SERVICE BULLETIN

This is a revised and up to date index of section 8 service bulletins. Please file in the beginning of section 8 of your service manual for easy reference to applicable bulletins. Also enclosed are additional index sheets to keep the index up to date. This index will become effective March 1, 1984.

INDEX OF SERVICE BULLETINS

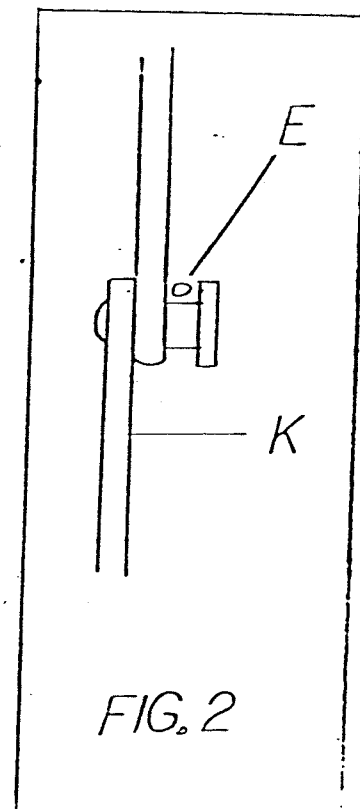
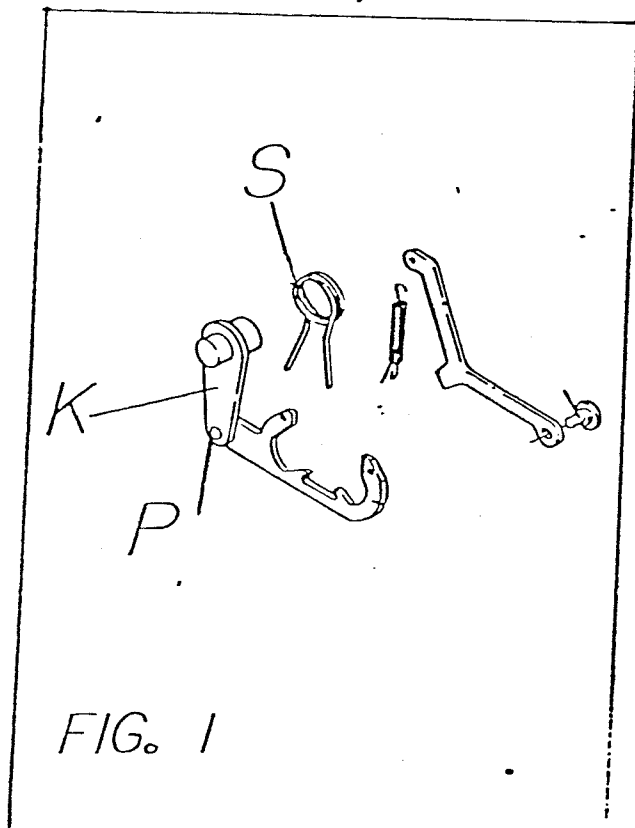
The possibility exists for the return spring (fig. 1, letter S) to work its way up the locating pin in the primary cover and become unhooked from the kicker (fig. 1 & 2, letter K). When this happens the shift lever will not change the gears correctly or return to its rest position. If you determine that this has happened, the following needs to be checked:

1. Lay motorcycle on right side or drain oil and leave motorcycle standing.
2. Remove primary cover, clutch assembly and kicker (fig. 1 & 2, letter K).
3. (Fig. 2, letter E) shows the correct position of the open arms of return spring (fig. 1, letter S) in its unsprung state. The open ends of this return spring should freely return into its groove (see fig. w, letter E). If the spring arms seem to not return to this position, then the spring will try to work its way out of (fig. 2, letter E) when the shifter is worked.
4. To repair, it may be a matter of simply turning the spring around and see how it fits or bend the open ends of the spring so the spring ends fit into (fig. 2, letter E) kicker.
5. Replace the kicker, clutch assembly, primary cover and re-fill with oil if necessary.

8-095

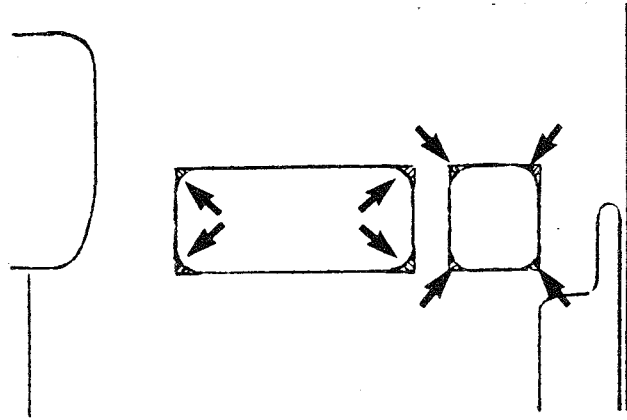
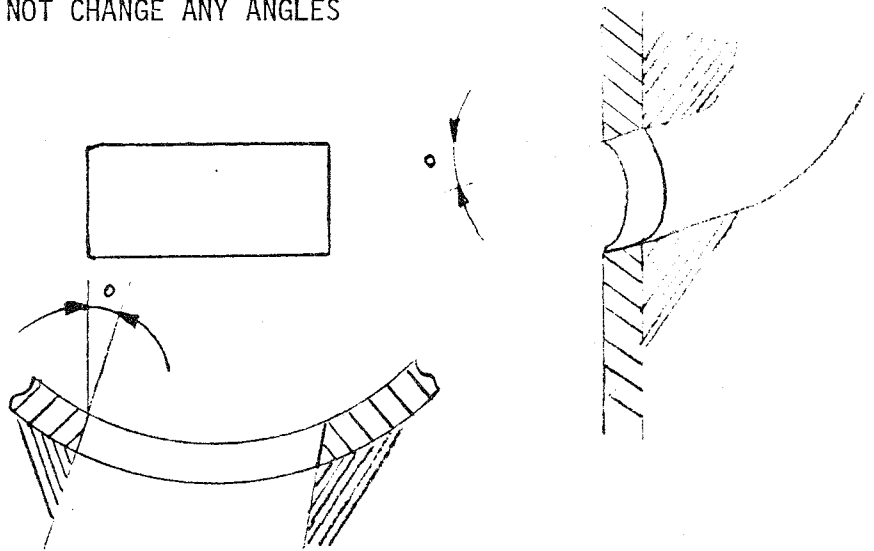
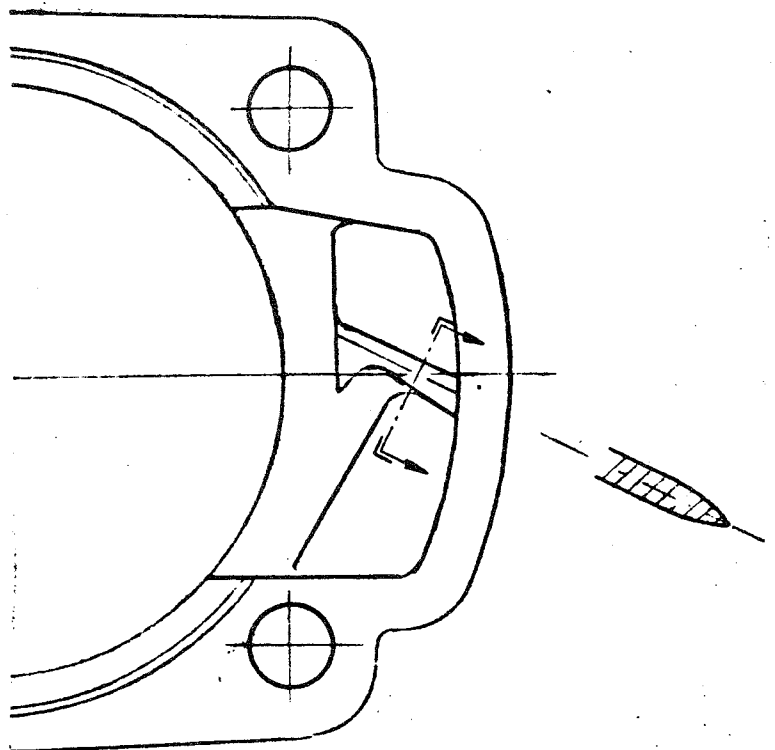
Transfers: Make the four transfers with sharp 90° angled corners.
See figure 1.

NOTE! Do not change any angles in the liner. See
figure 2.

Remove material according to figure 3.

8-097

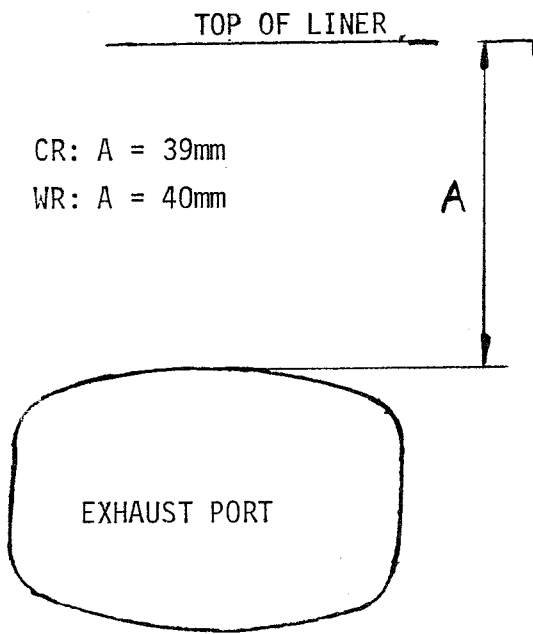
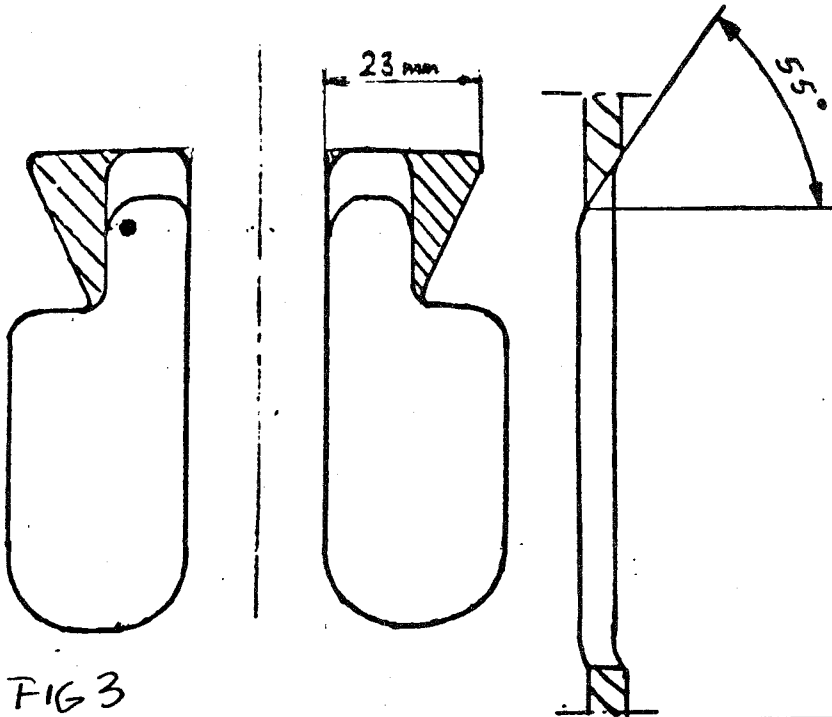
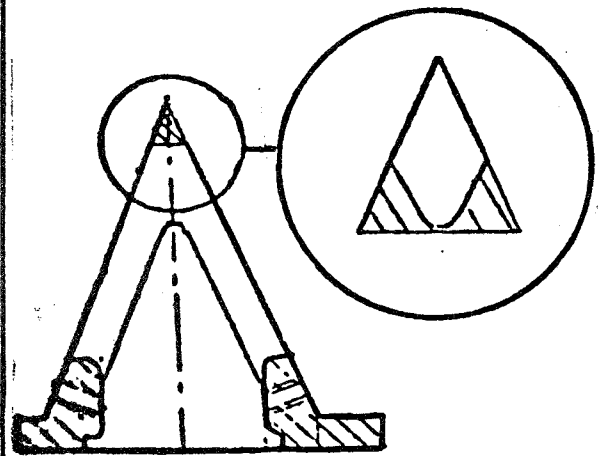
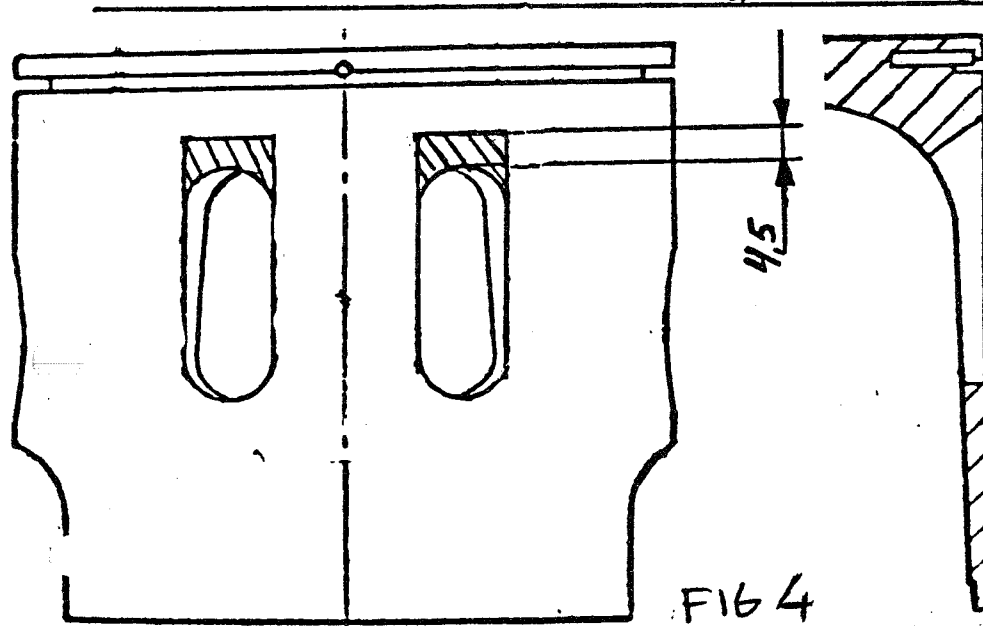
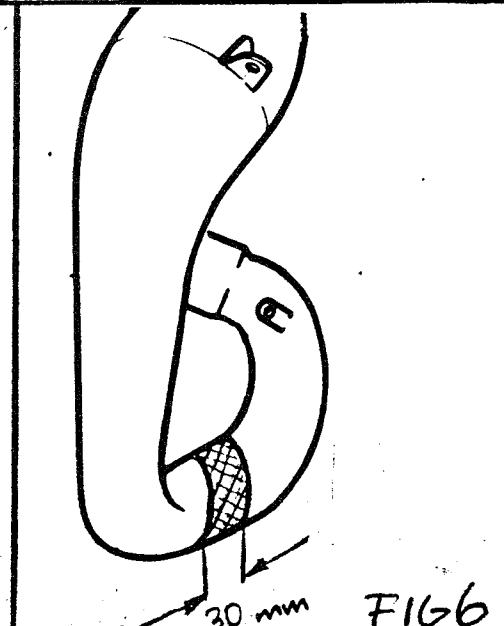
Exhaust port: See figure 1. Distance from exhaust port to top of cylinder should be 39,0mm on CR's. WR's should have 40,0mm (same as on 430, 1981 - some early 430 82's can have 40mm).

Transfers: Make the rear corners of the transfer ports in a 90° angle and sharp. See figure 2.

Intake port: The upper part should be worked according to figure 3.

Piston: The two windows in the piston should be raised as shown in figure 4.

All big irregularities should be adjusted. The front part of the valve holders should be tapered. See figure 5., but not more than to the point where the reed valve has a safe contact surface. Mossbarger reed available from Husky Products.

Exhaust pipe: 430 WR's can benefit from lengthening the pipe 30mm according to figure 6. This gives a different power-band.

FIGURE A

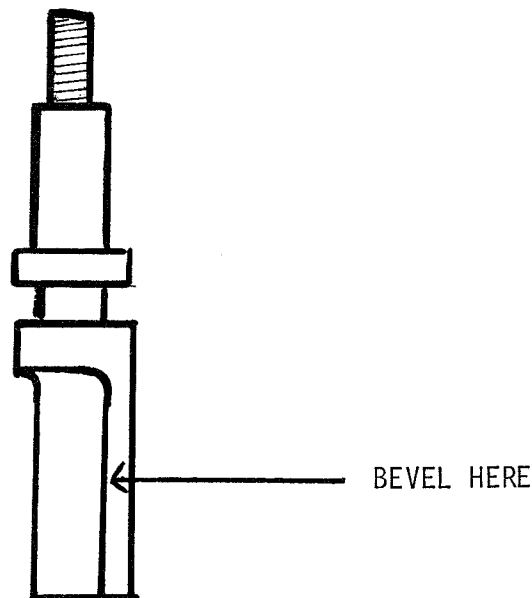
In the event that a "click" is heard from the engine area when the clutch lever is pulled in, the following needs to be done.

1. Unhook the clutch cable from the lever that sits atop the engine cases.
2. Remove the set screw that locates the pictured (fig. A) clutch release shaft and the shaft itself. A prying instrument will probably be needed.
3. Increase the radius slightly at the edge indicated by an arrow. This may be done with emery paper and remember only a little increase in the radius is enough.
4. Clean thoroughly and replace. Install set screw and cable. Clicking noise should now be gone.

Fig. 3

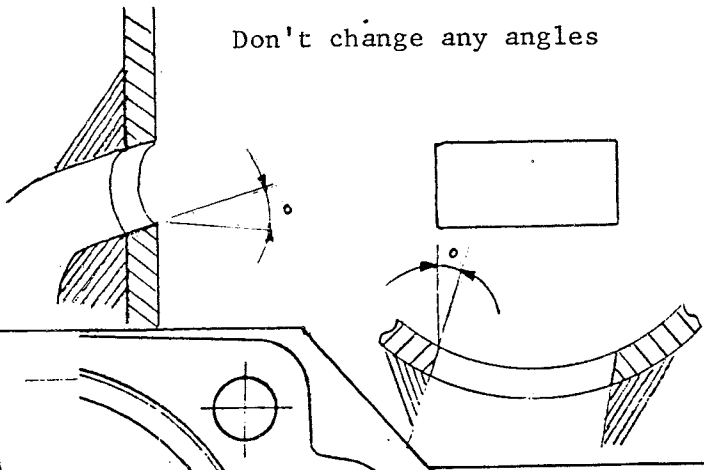
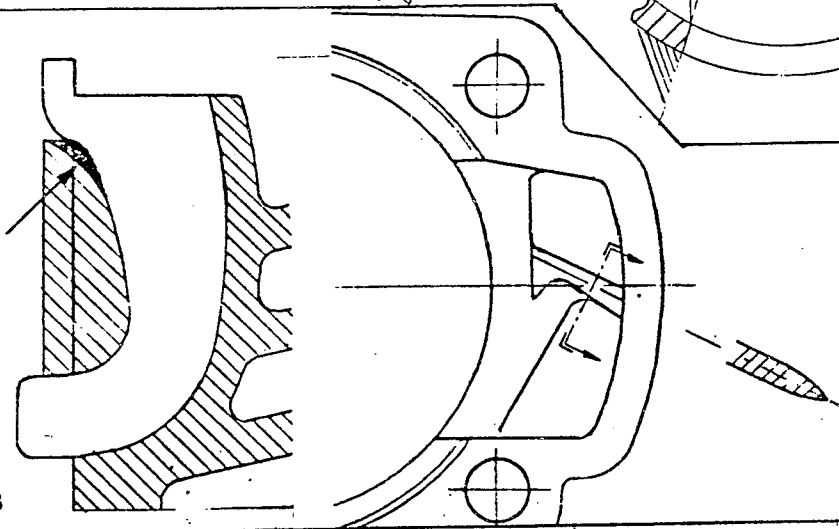
Transfer ports - Make the four transfers with 90° angled corners (fig. 1). The best way to do this is to remove the liner from cylinder, hand file the corners, refit to cylinder and rebore. Do not forget to adjust the aluminum to the new shape of the ports. Don't change the angles in the liner (fig. 2). Remove material according to figure 3.

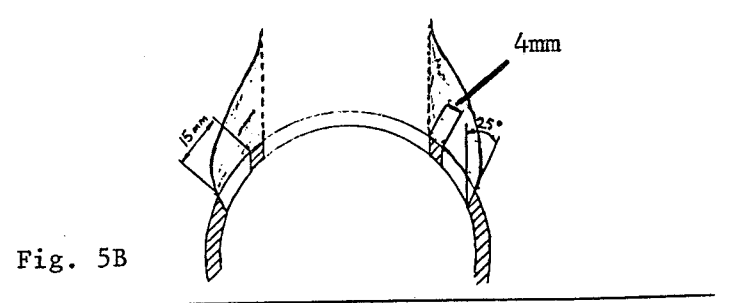
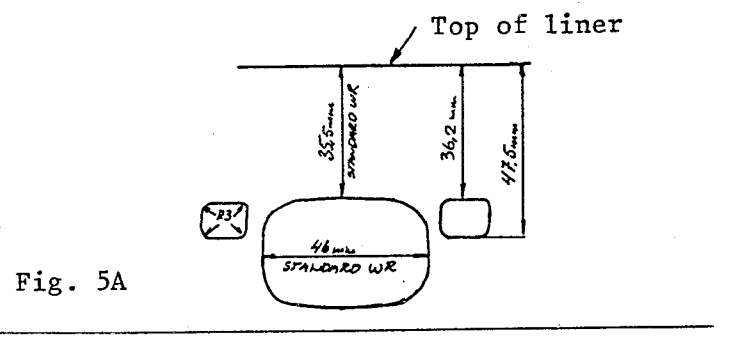
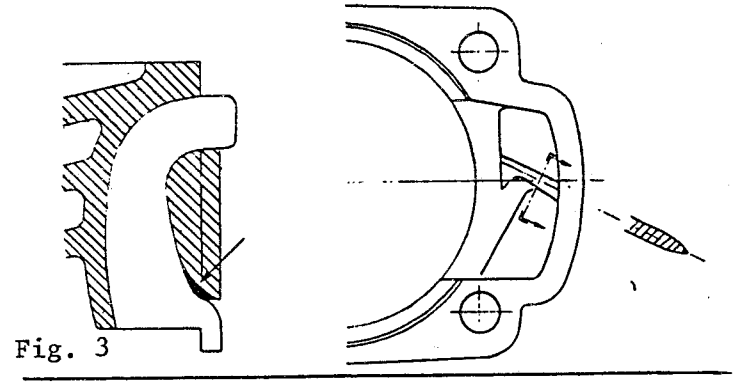
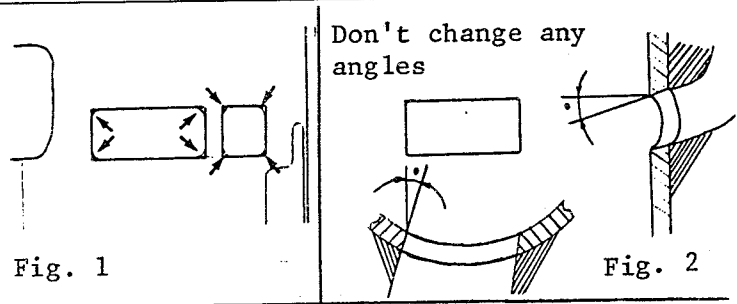
Transfer ports - Using liner from 250 WR make the four transfers with sharp 90° angled corners (fig. 1). The 250 WR liner has the ideal height and width of exhaust port. Do not change any angles in the liner (fig. 2).

Remove material according to figure 3.

Piston - Raise the windows according to figure 4.

Exhaust port - Make two new ports in liner on each side of exhaust port. See figure 5A.

Remove material in the cylinder to fit the new ports in liner (fig. 5B). Do not catch the cylinder stud holes when doing this.

Exhaust pipe - Lengthen exhaust pipe 20mm according to figure 6.

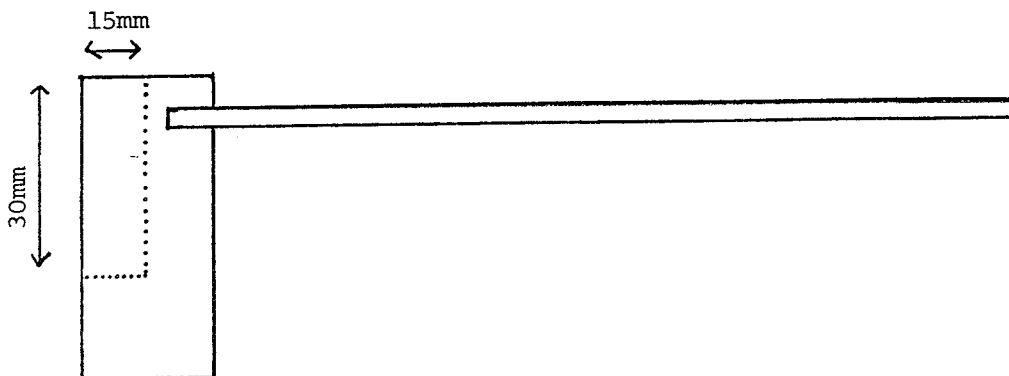
The spark plug wrench supplied in the tool kit may not clear the exhaust pipe. Pictured below is a simple modification to enable the stock wrench to reach the spark plug without coming in contact with the exhaust pipe.

RE: NEW STYLE FUEL TANK TOUCHING FRAME.

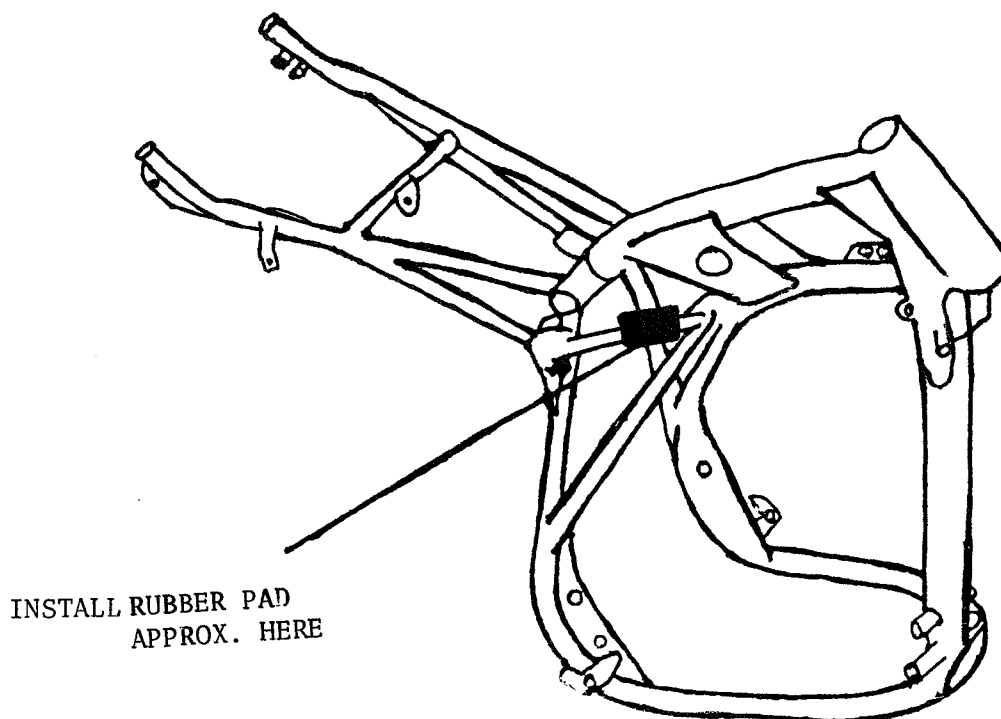
We have found that the possibility for the gas tank to touch the frame exists.

The gas tank resting on the frame can cause the tank to seep around the molded in "J" hook.
